## 142.2.4 FEC encoder

### 142.2.4.1 Low Density Parity Check coding

Figure 142–1—FEC encoder

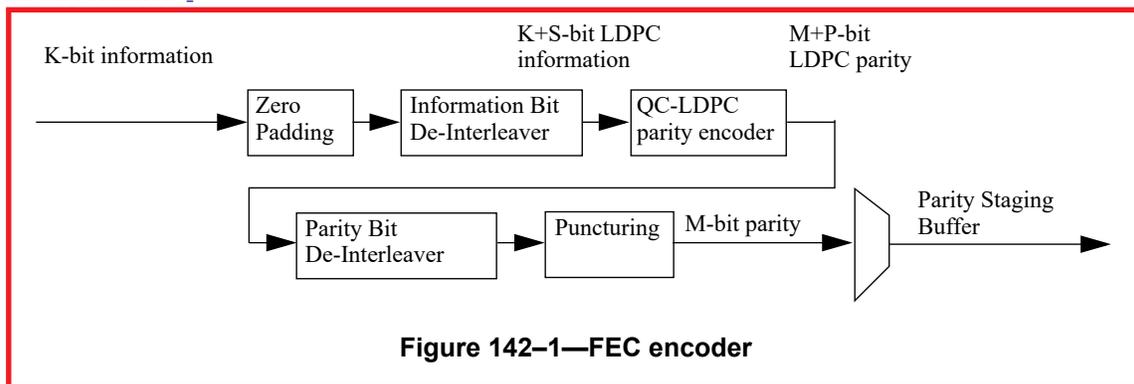
The Nx25G-EPON PCS shall encode the transmitted data stream using LDPC(16952,14392) FEC, defined in 142.2.4. ~~Annex 142A gives an example of LDPC(16952,14392)-FEC encoding and interleaving encoder test vectors are provided in Annex 142A.~~

~~The bit sequence input for a given code block to the FEC Encoder is denoted by  $u_1, u_2, \dots, u_K$ , where  $K$  is the number of bits to be encoded. The parity check bit sequence produced by FEC Encoder is denoted by  $p_1, p_2, \dots, p_M$ , where  $M$  is the number of parity check bits. The output of the FEC Encoder is denoted by  $e = [e_1, e_2, \dots, e_N] = [u_1, u_2, \dots, u_K | p_1, p_2, \dots, p_M]$ , where  $N = K + M$  is the length of the encoder output sequence.~~

Figure 142-6—FEC encoder

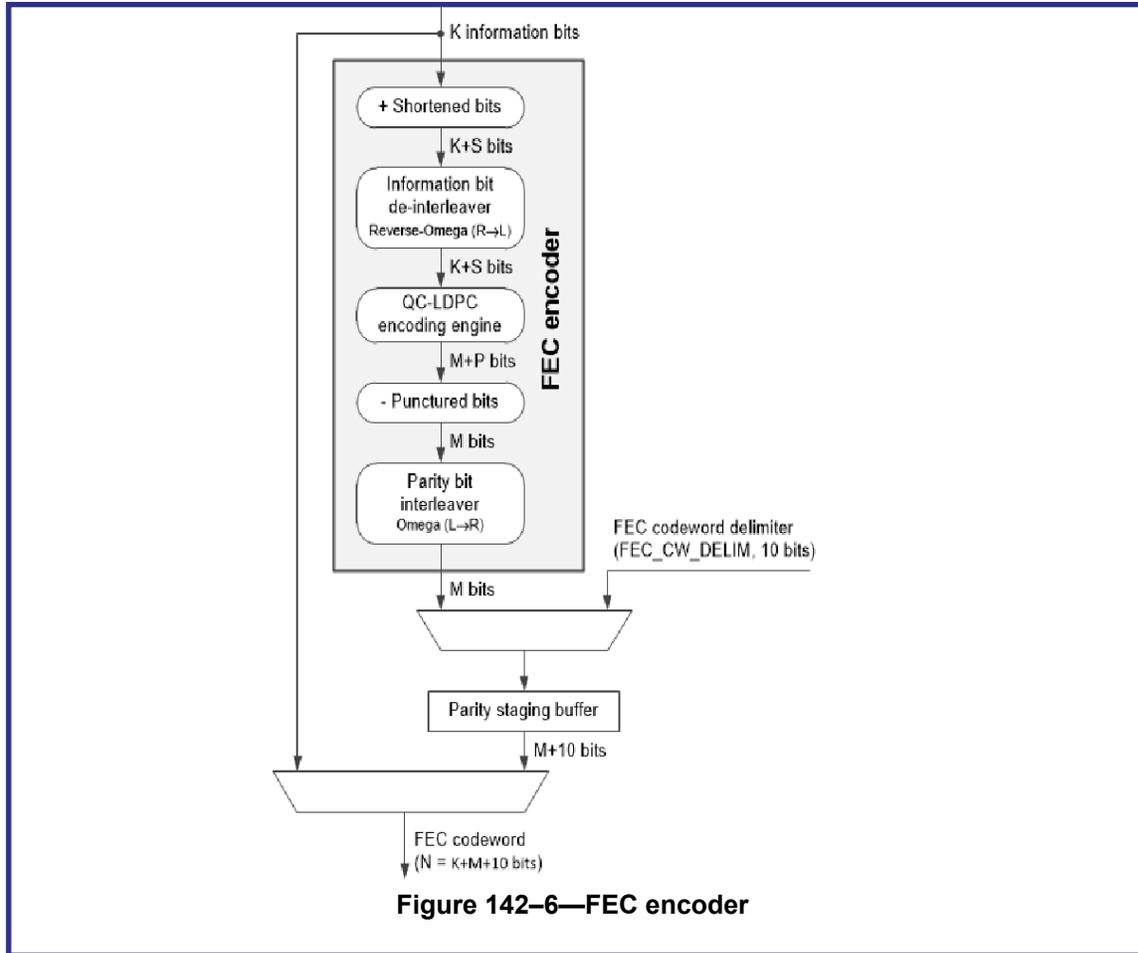
The FEC ~~encoding scheme encoder~~ is shown in Figure 142–6. The ~~scheme encoder~~ consists of a systematic QC-LDPC ~~encoder and encoding engine followed by~~ a shortening and puncturing ~~mechanism~~ and the addition of a 10-bit delimiter. The parameters of the FEC ~~encoding scheme encoder~~ are:

- the LDPC parity check matrix is a 12-by-69 ~~quasiarray of circulant sub-eyelie matrix, matrices (see 142.2.4.2)~~ with circulant size  $Z = 256$ ; LDPC user bit length before shortening is  $57 \times 256 = 14592$ , the parity bit length before puncturing is  $12 \times 256 = 3072$ ; the codeword length before any shortening and puncturing is 17664;

- the number of transmitted information bits,  $K$  (with maximum user length  $K_{\max} = 14392$ );
- the number of shortened information bits,  $S$  ( ~~$S_{\min} S = 20014592 - K$~~ );

- the number of punctured parity check bits,  $P$  ( $P = 512$ );
- the number of parity-check bits after puncturing,  $M$  ( $M = 3072 - 512P = 2560$ );

- the ~~number length of the FEC encoder output bits, + delimiter is  $N$  (where  $N = K + M$ , FEC code word, whose size depends on the burst length pattern to determine shortening length); + 10-bits and  $N_{\max} = K_{\max} + M + 10\text{-bits} = 1695216962$~~ ;

The LDPC encoder as shown in Figure 142–6 places the  $M$ -bit FEC parity bits into the *ParityStagingBuffer* for use by the PCS Transmit Process (see 142.2.5.4.3) and the `FecParity()` function. The buffer is comprised of 2560 bits of calculated parity along with the 10-bit codeword delimiter (`FEC_CW_DELIM`). This results in the parity bits assigned to `ParityStagingBuffer<2559:0>` and the 10-bit `FEC_CW_DELIM` value to `ParityStagingBuffer<2569:2560>`. The transmission order starts with bit 0 and ends with bit 2569.
